HORSHAM DISTRICT COUNCIL CONSULTATION

TO:	Horsham District Council – Planning Dept
LOCATION:	Land North of Horsham Old Holbrook Horsham West Sussex
DESCRIPTION:	Application for approval of Reserved Matters pursuant to Condition 5 of Outline Planning Permission reference DC/16/1677 for the extension of the Phase 1 Primary Road to Old Holbrook, landscaping, SUDS, ecological enhancements, substation, footbridge and the Sub Phase 1D Strategic Landscape Buffer. OPP accompanied by an Environmental Statement.
REFERENCE:	DC/24/0446
RE-CONSULTATION:	1st of comments in black 2nd set of comments in blue 3rd set of comments in green
RECOMMENDATION:	Modification / Holding Objection

SUMMARY OF COMMENTS & RECOMMENDATION:

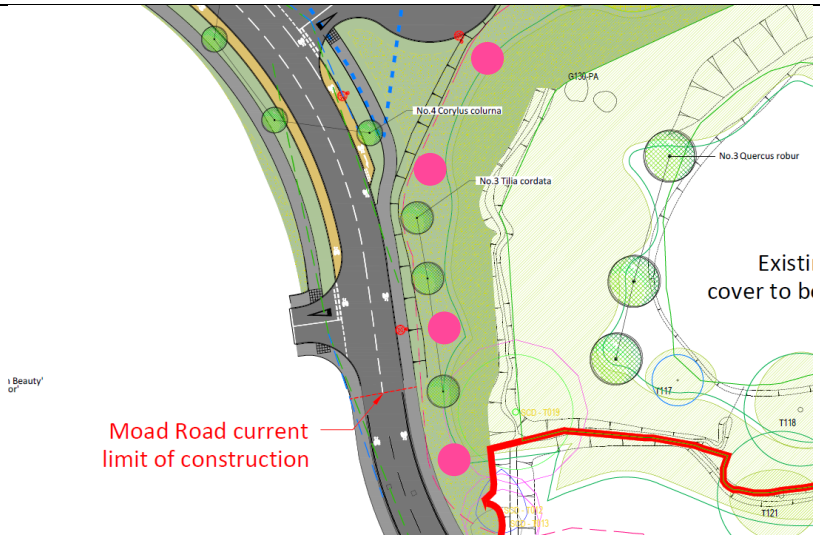
Any mitigation planting within AW is not acceptable on landscape grounds due to likely deterioration and loss of AW caused by maintenance access through existing AW. Mitigation planting must be located within or outside the AW buffer, as previously requested.

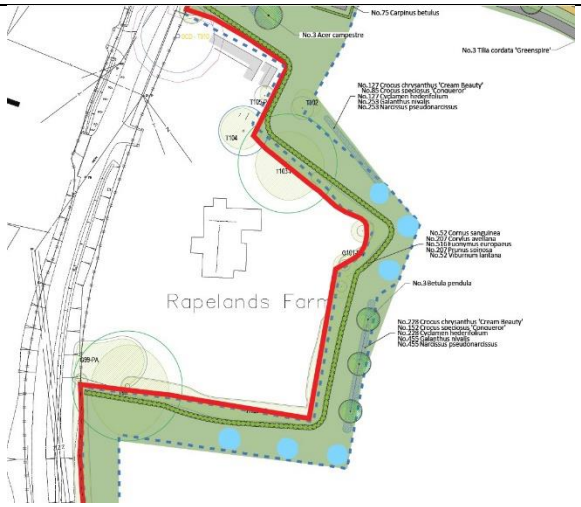
4. For tree planting adjacent to the AW buffer zone, we recommend removing Tilia cordata 'Greenspire', Corylus colurna and Acer rubrum and replacing with trees listed within the revised planting palette under DC/24/0061. This is based on guidance from the Woodland Trust which recommends creating native woodland around ancient woodland to reverse fragmentation, thereby increasing ecological connectivity to form resilient landscapes. From a landscape perspective, the trees listed above are not local features within the I2 – Warnham and Rusper Wooded Edge and K2 – Warnham and Faygate Vale Landscape Character Areas from which the proposed site is located. Recommended alternatives such as Tilia cordata and Sorbus torminalis are found within the Landscape Character Areas and are also key ancient woodland species appropriate for the buffer location. Amendment to Tilia cordata is welcomed, however proposed Quercus robur within the pond area should be removed to prevent disturbance within AW via maintenance activities, and to allow for natural regeneration. As an alternative, there is opportunity for further planting within the AW buffer zone (see indicative areas in pink, below) to mitigate adverse effects as described in the summary of comments. Please consider key ancient woodland species such as Sorbus torminalis, as species diversity is necessary for resilient landscapes.

Not yet addressed. As previously noted, the newly proposed location requires planting and maintenance access through existing AW, thereby introducing further effects of development contributing to its deterioration and loss, which is of key landscape concern. Please relocate mitigation planting to the AW buffer, which will more likely achieve goals of maximising ecological integrity and resilience by diffusing effects from the road.
